Hearing Date COA# INDIANAPOLIS HISTORIC PRESERVATION AUG. 4, 2010 **COMMISSION** 2010-COA-192 (CAMA) STAFF REPORT 612 East 9<sup>th</sup> Street Continued from: July 7, 2010 CHATHAM-ARCH MASSACHUSETTS AVENUE Applicant PATRICIA BIDDINGER 612 East 9<sup>th</sup> Street mailing address: Indianapolis, IN 46202 Owner: Same as above Center Twp. Council District 9 **CASE** Jackie Nytes Retain siding as installed on garage not in compliance with **IHPC COA:** 2010-COA-192 (CAMA) previously issued COA. STAFF RECOMMENDATION: Approval of staff recommended compromise, or Denial

CASE #2010-COA-192 (CAMA):

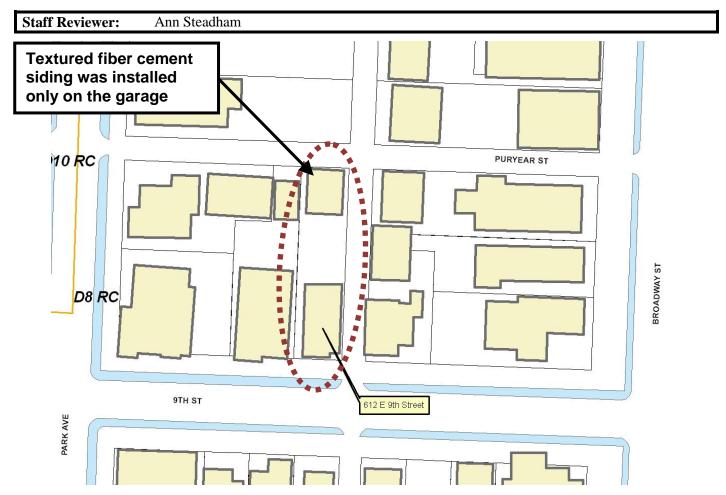
The applicant was informed that the siding installed on the detached garage is not considered "appropriate." The applicant applied to retain the siding as-is. Staff recommended the applicant either plane down (sand) the surface of the fiber cement siding or replace the siding with new material with a smooth surface texture.

The siding that was approved on the upper floor of the house and the detached garage was a fiber cement siding with a smooth, ungrained surface texture. The Chatham-Arch Massachusetts Avenue Plan specifically recommends "new architectural elements added to a non-historic building should be of a simple design compatible with the building and not visually intrusive within the district". The siding installed on the detached garage is Hardie-Plank with an embossed wood grain surface texture. This heavy graining effect is not consistent with the visual quality of smooth sanded siding traditionally found in the historic area. The commission has consistently rejected this siding since it developed its "hardboard siding" policy in the mid 1980s. The use of the embossed siding is very visible on the detached garage from the alleys. Its use will have a substantial visual effect on the building.

<u>To approve</u> a Certificate of Authorization to retain siding as installed on garage not in compliance with previously issued COA #2009-COA-464 (CAMA); per submitted documentation and subject to the following stipulations:

- 1. Two-coats of Porter-Flex Elastomeric Patching Compound must be applied on the surface of all existing textured siding on the garage to give the siding the appearance of a smooth surface texture.
- 2. The patching compound shall create a smooth surface free of apparent trowel lines or marks.
